NORTHCREST CENTER DEVELOPMENT PLAN

CONSTITUTION AVE & CANADA DR
COLORADO SPRINGS, COLORADO

Please add "PCD File No. PPR-21-036".

DEVELOPMENT PLAN
-COVER SHEET

ENG:	SAM	
DRAWN:	ASP	
CHECKED:	SAM	
DATE:	06/18/2021	
#	REVISION	DATE
JOB NO.:	180649	
SHEET NO.:	DP.06	
	of TBD

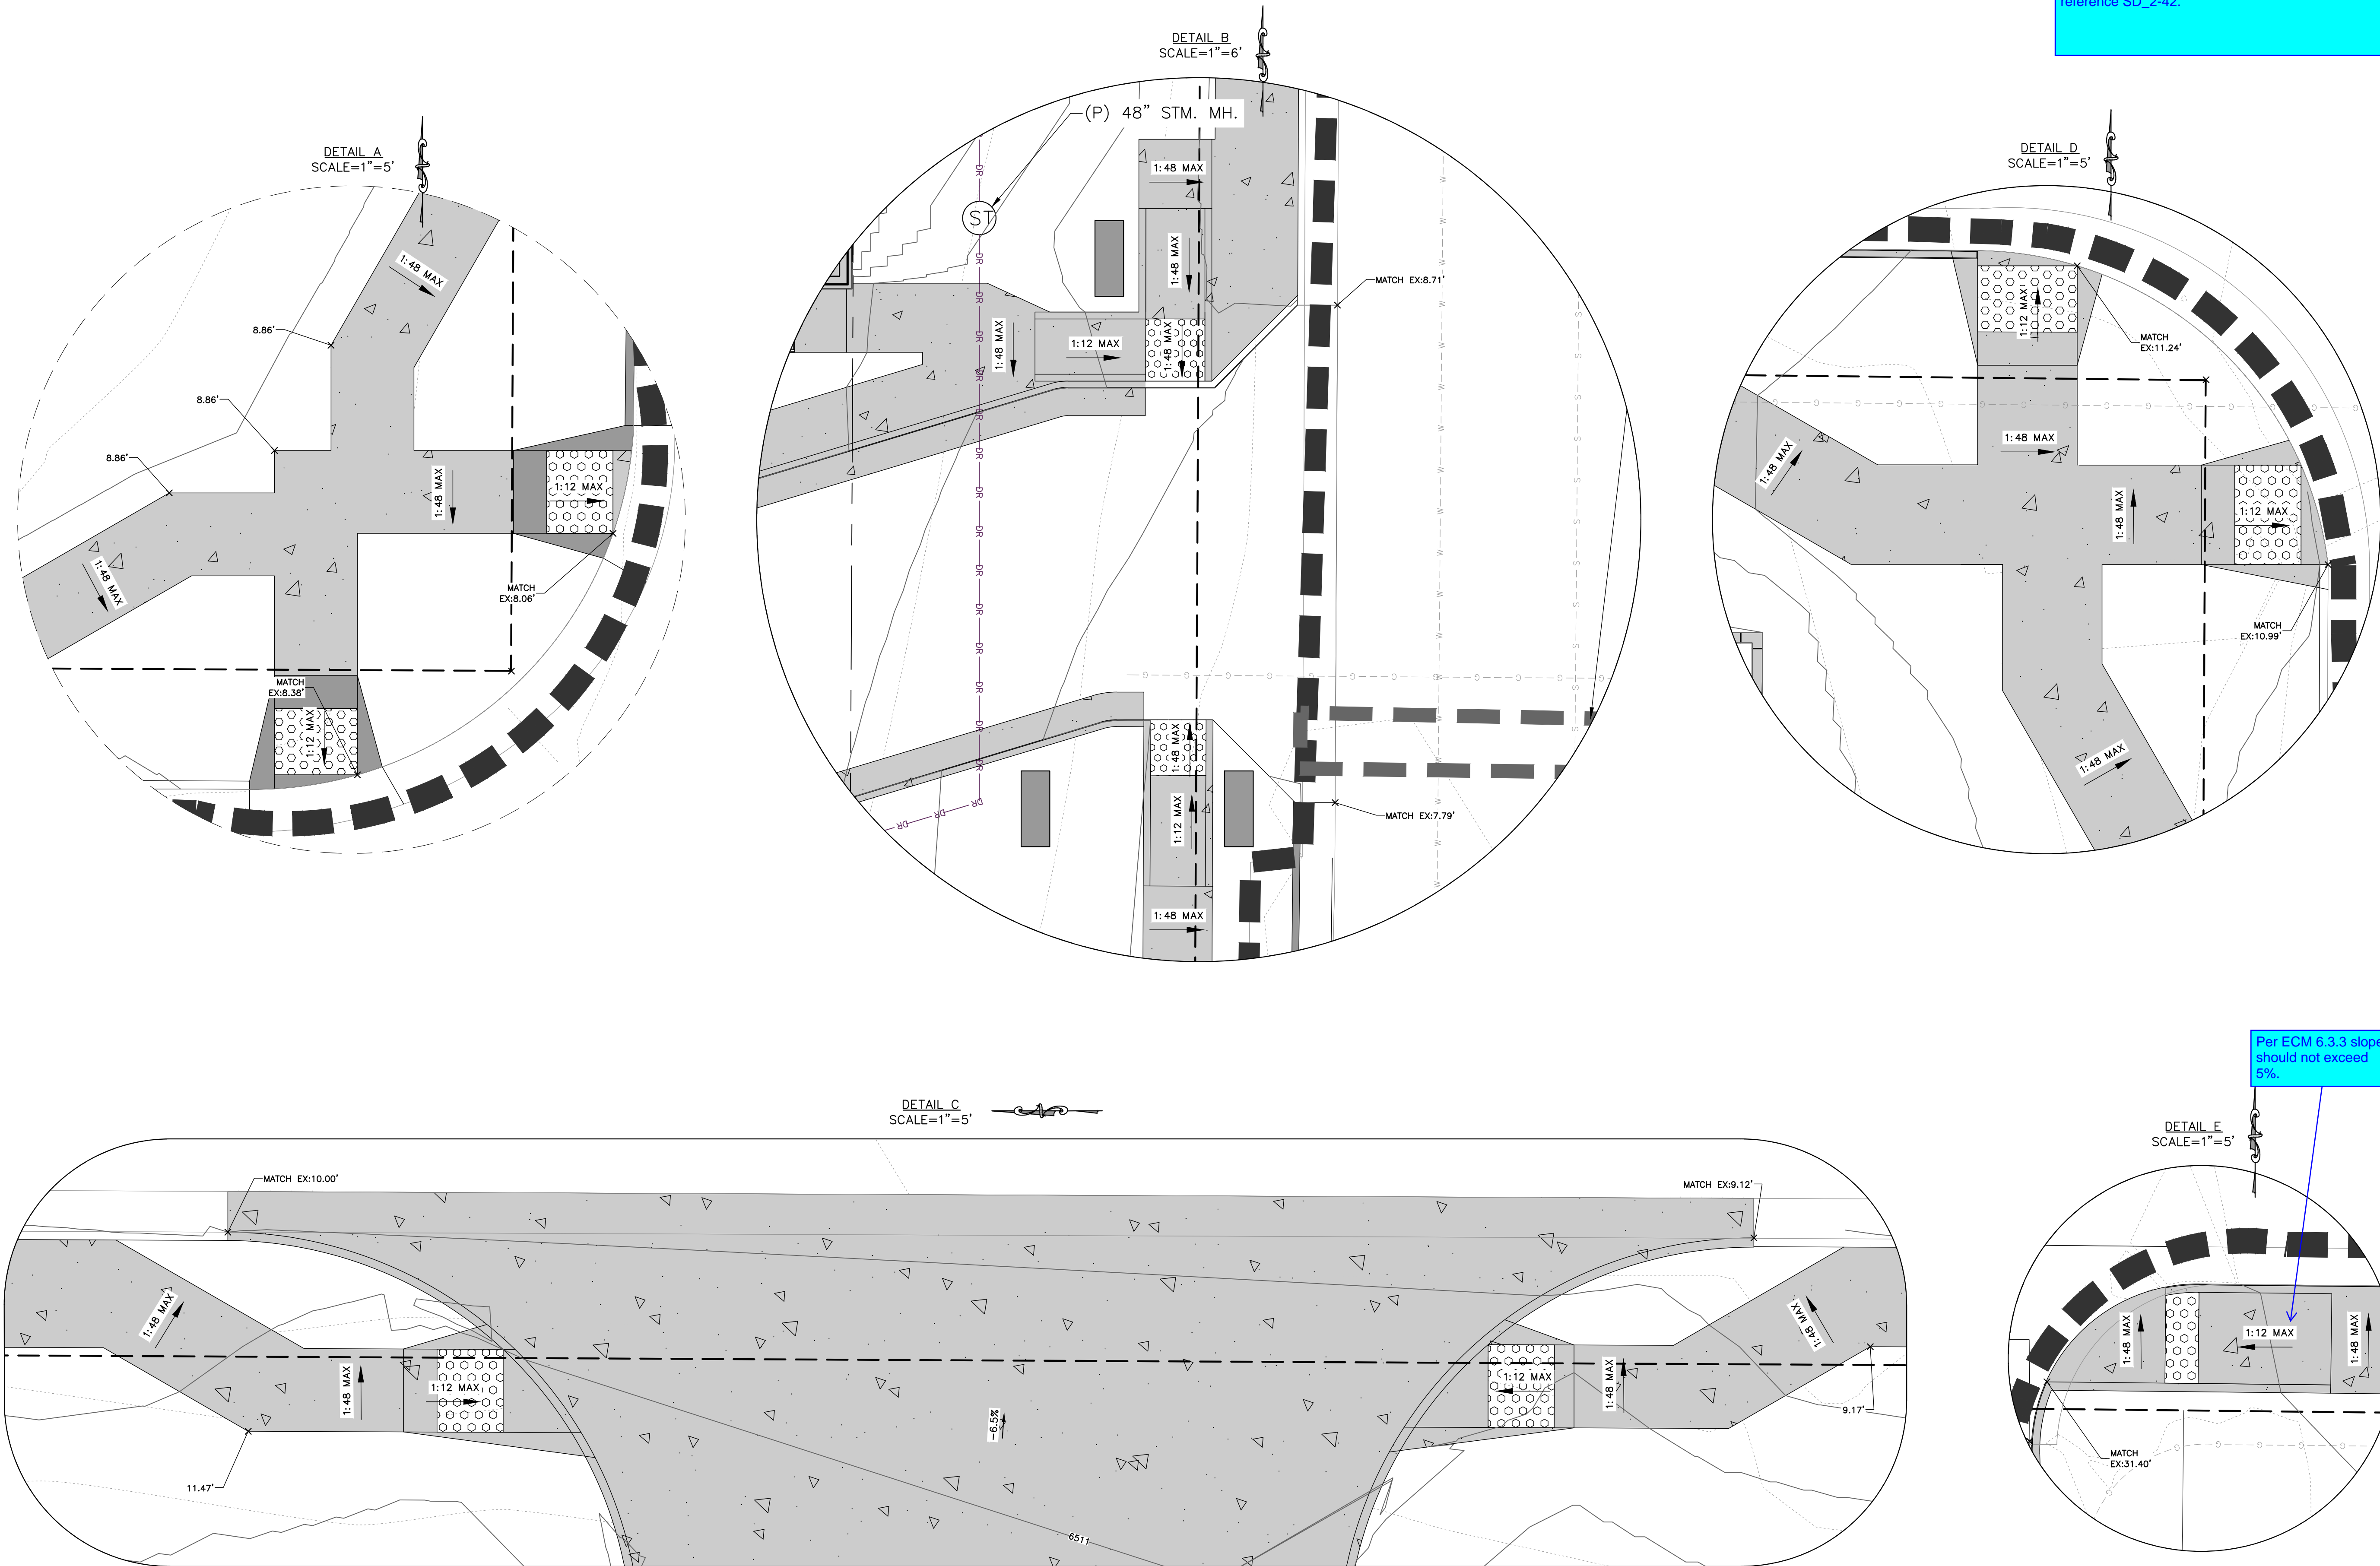
Please provide a detail for the truncated dome pads, reference SD_2-42.

Per ECM 6.3.3 slope should not exceed 5%.

E TYPE 2 CURB AND GUTTER
NOT TO SCALE

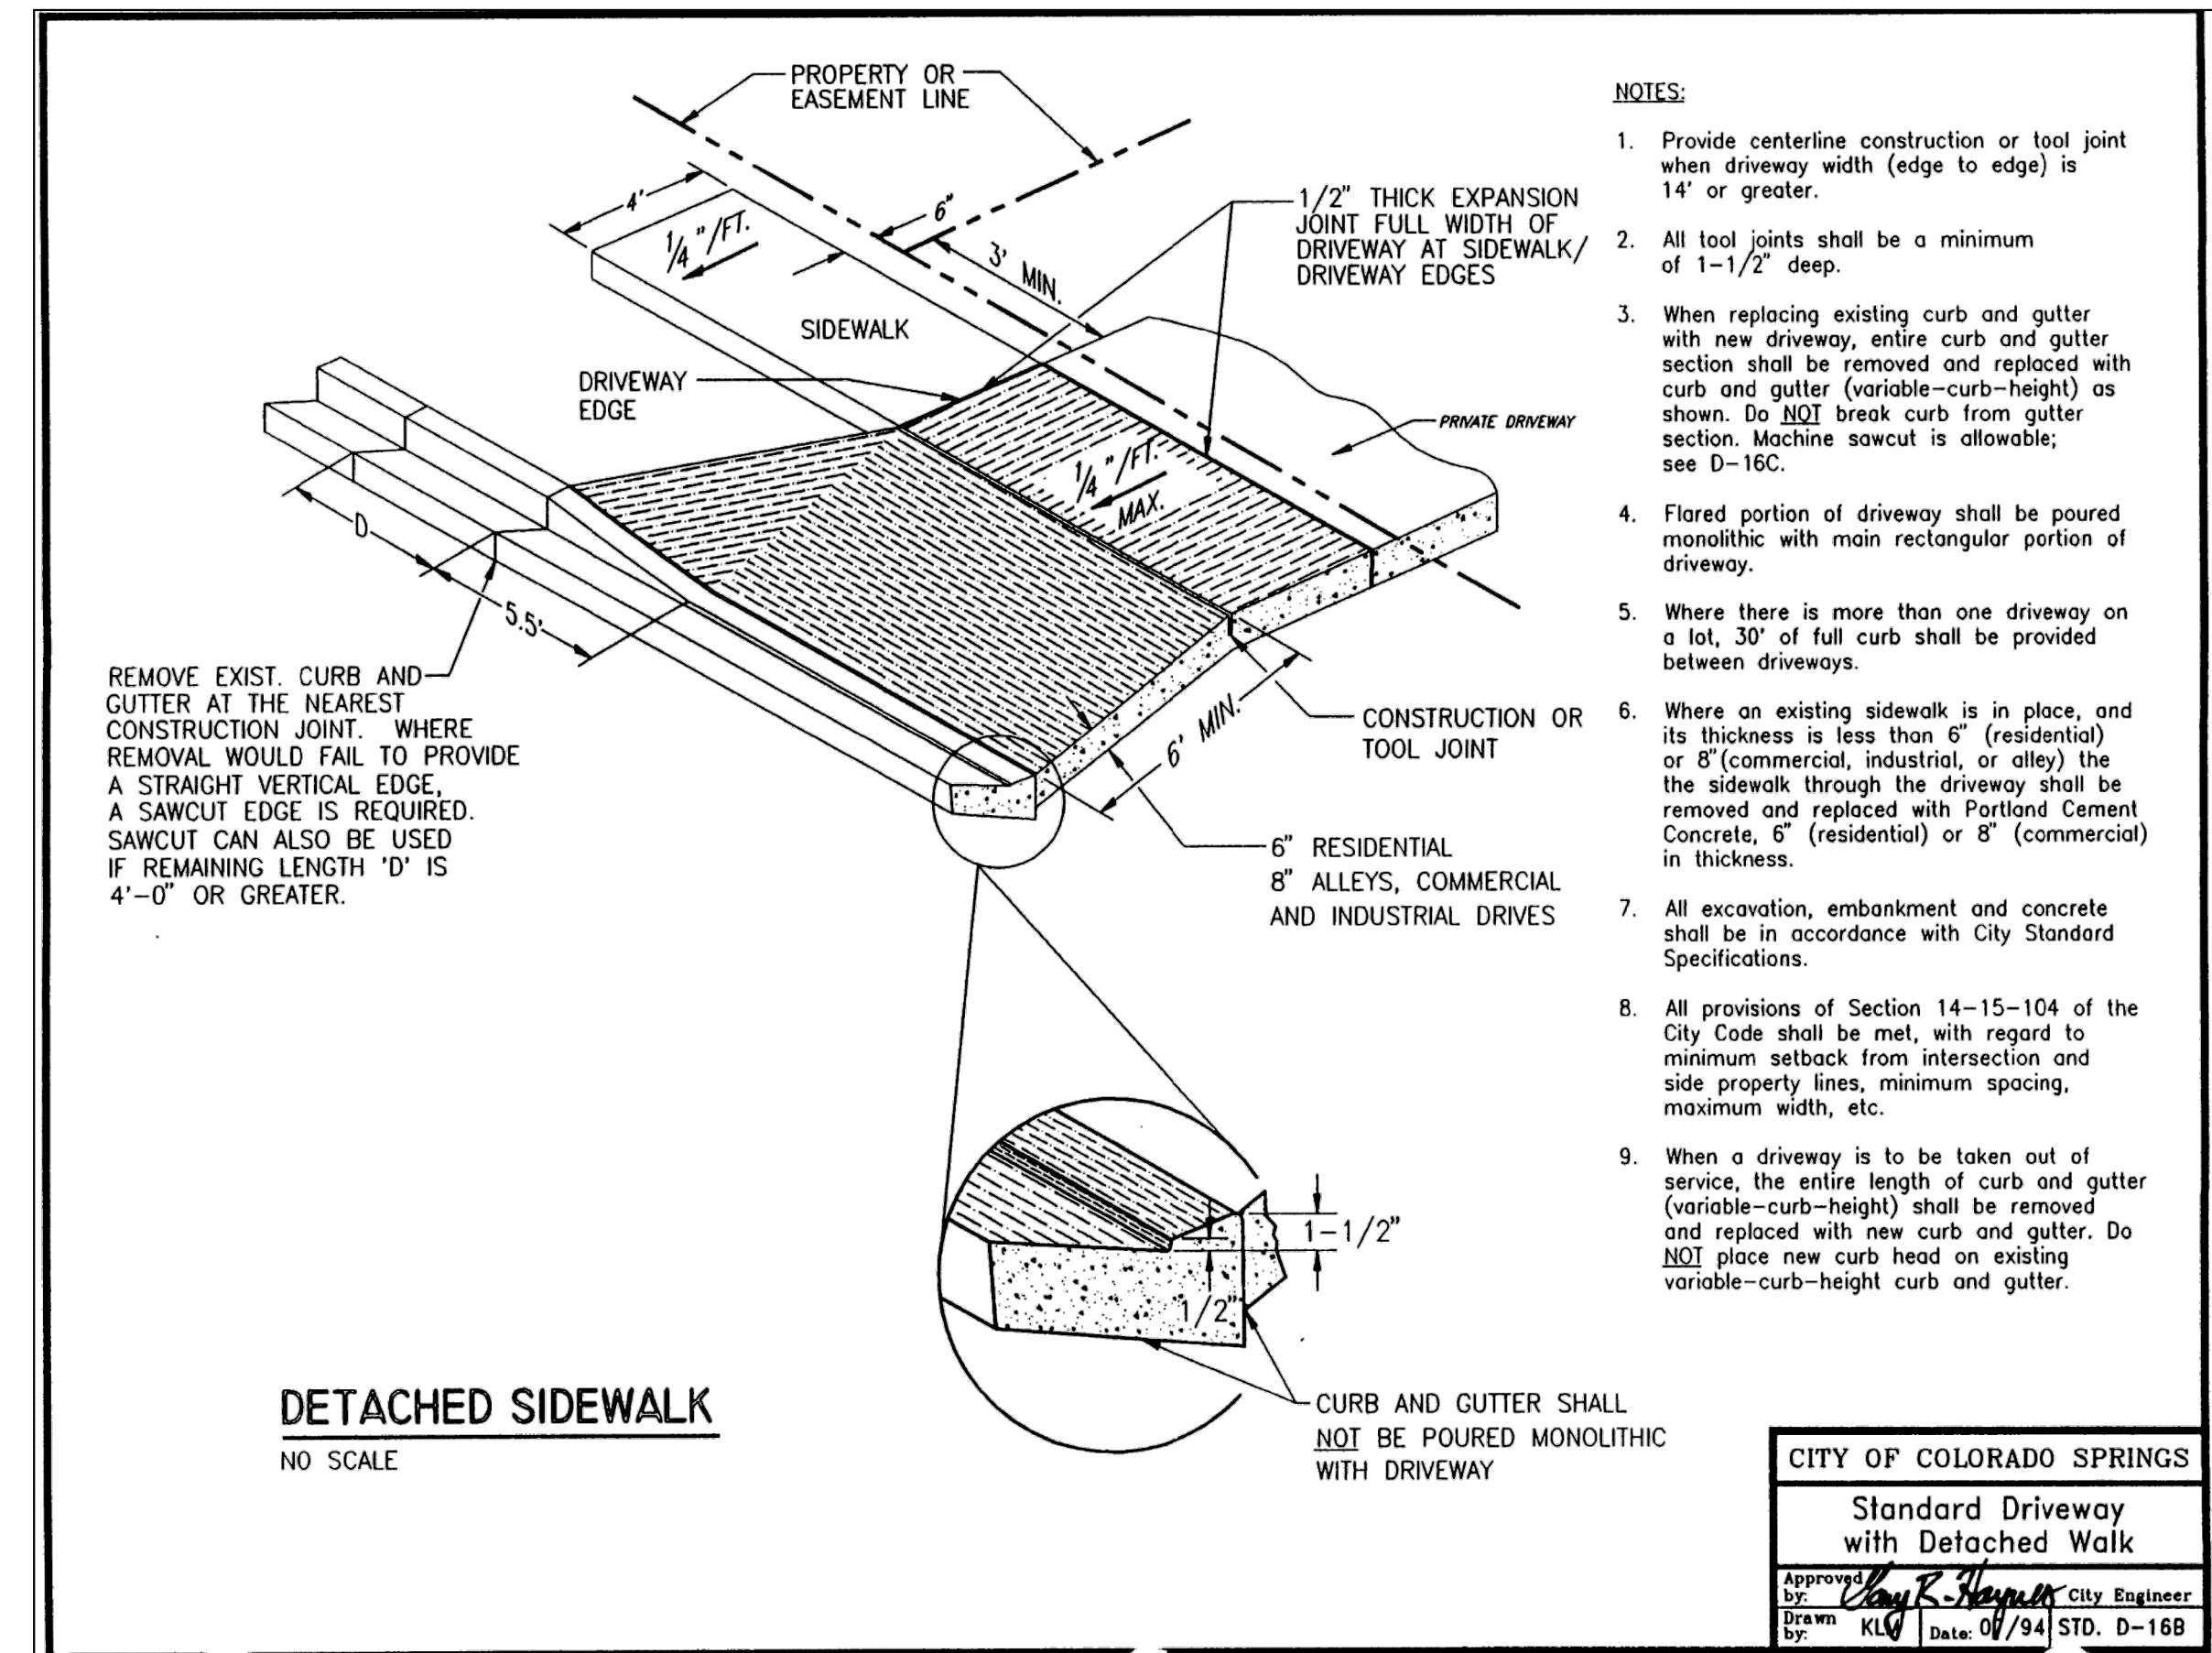
Please revise to use ECP optional type C curb and gutter. Reference ECM detail SD_2-20.

LP.01

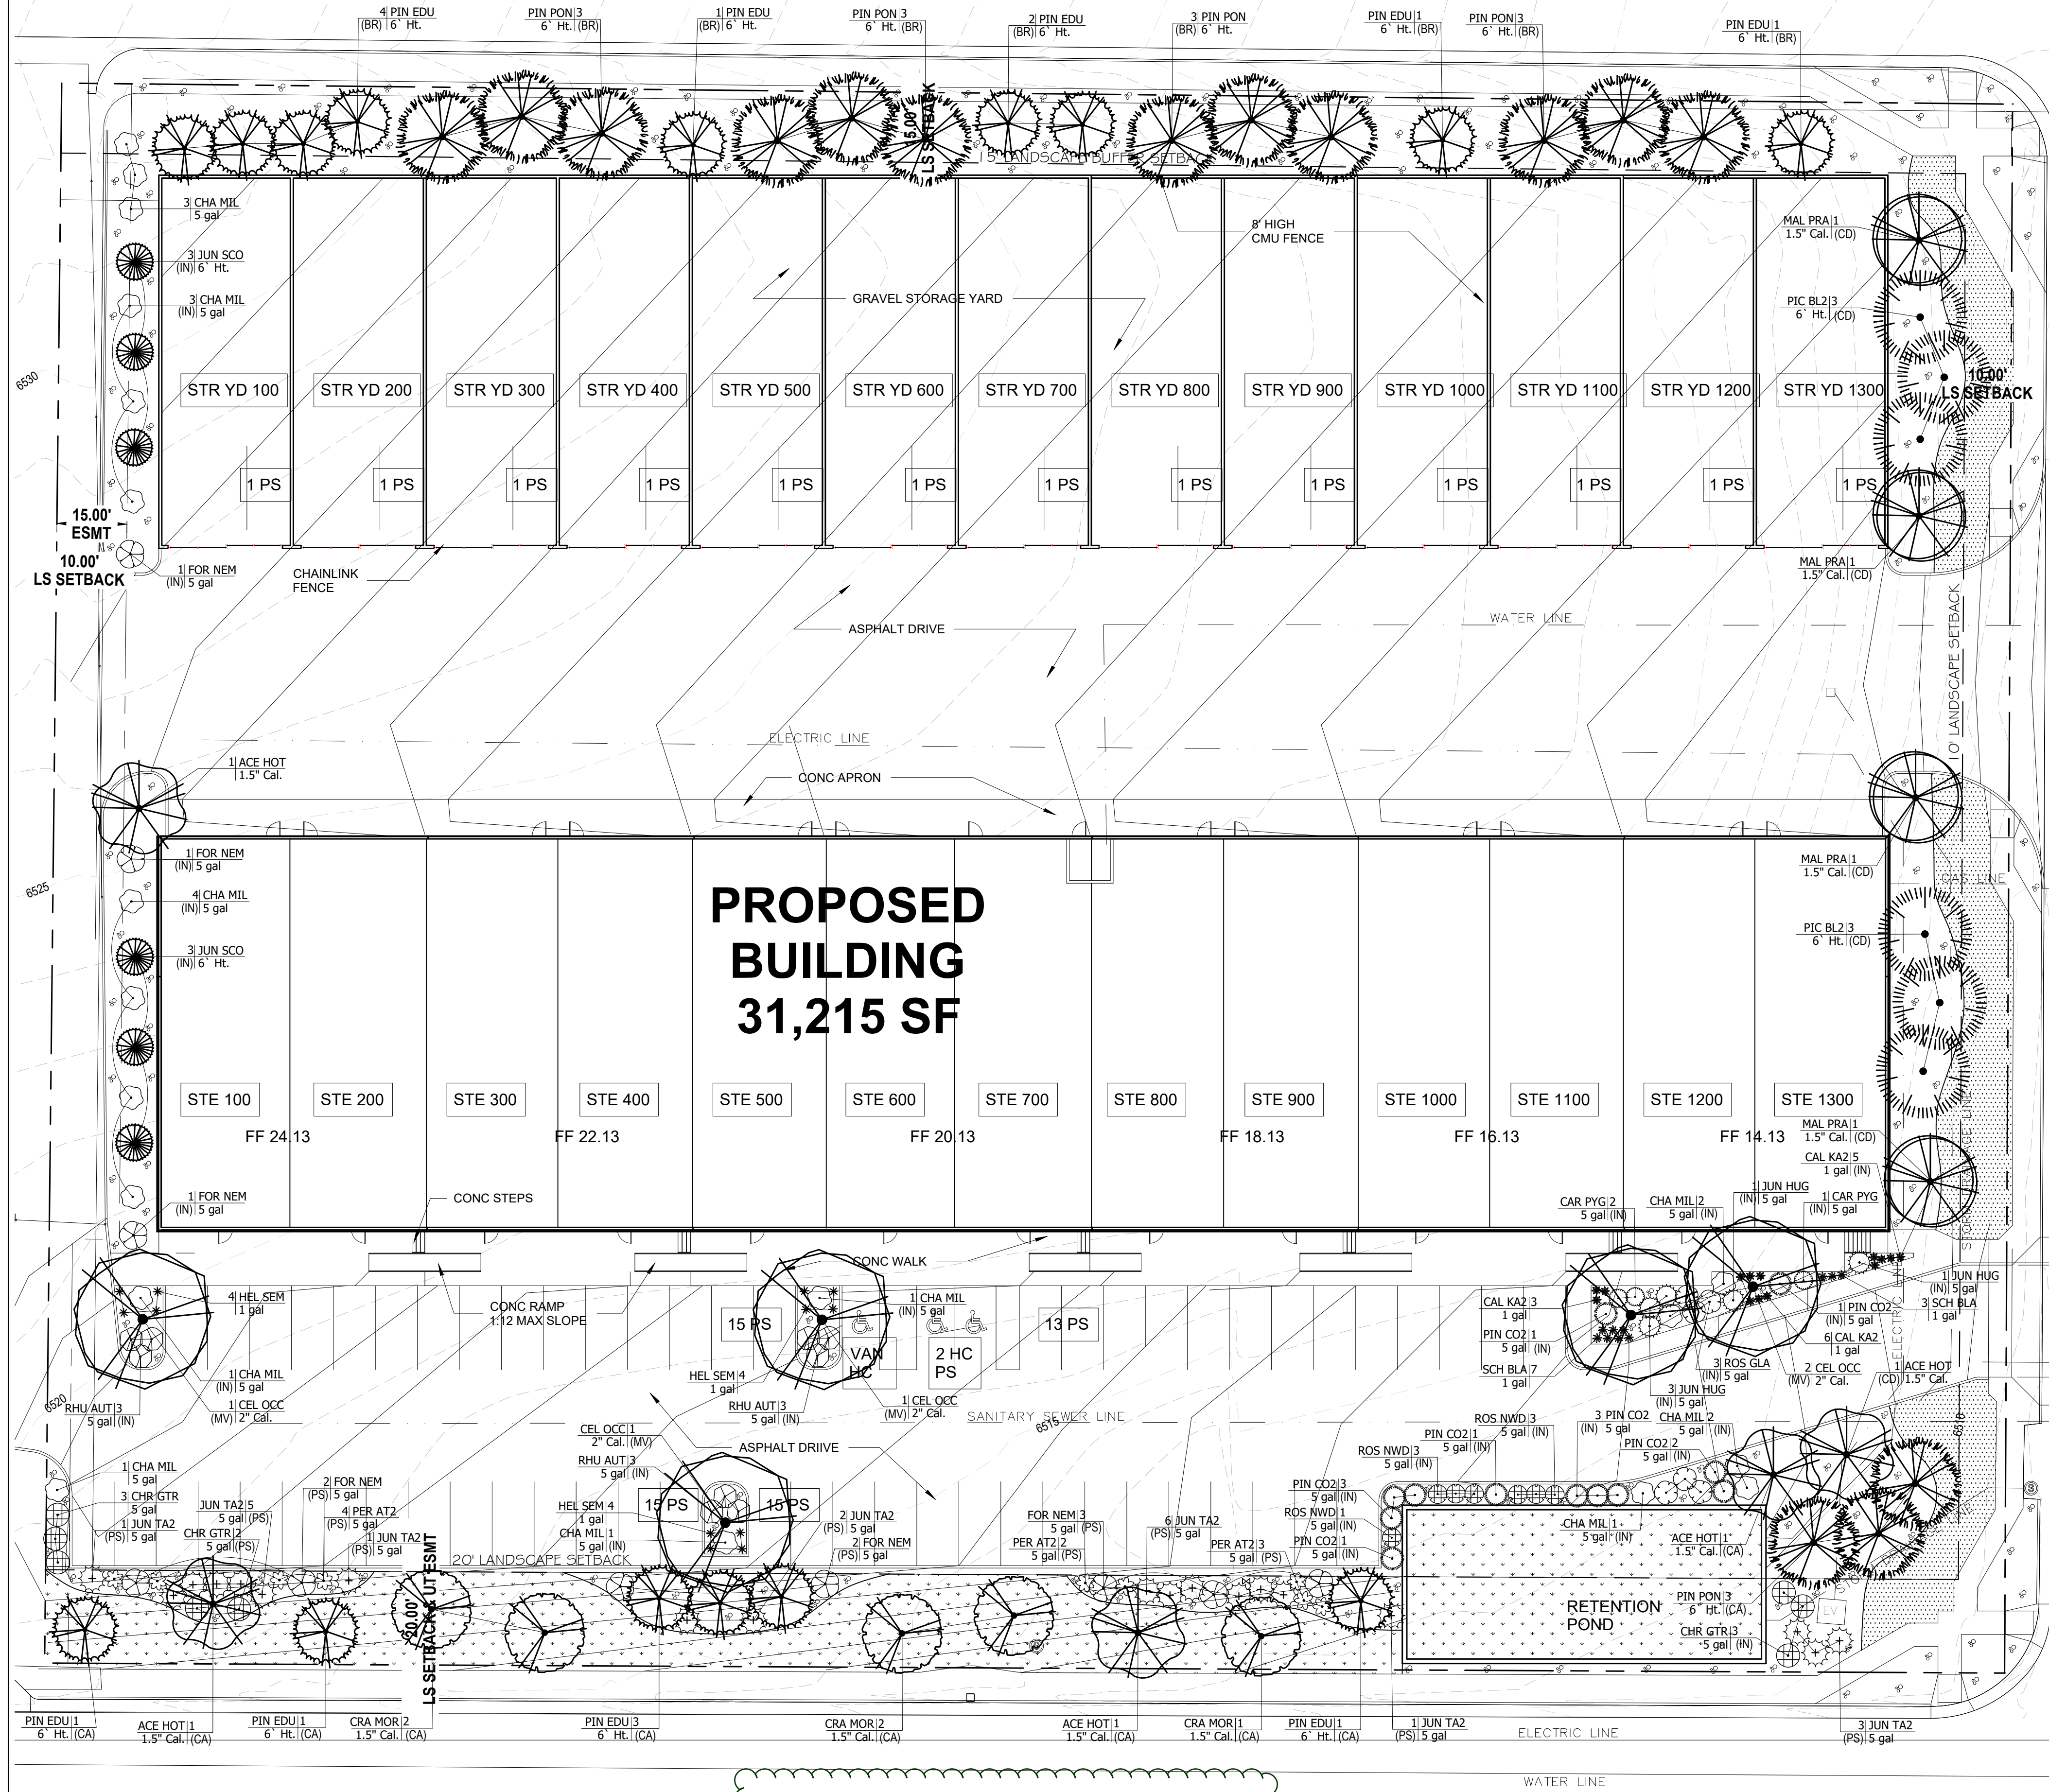
Show roadway classification
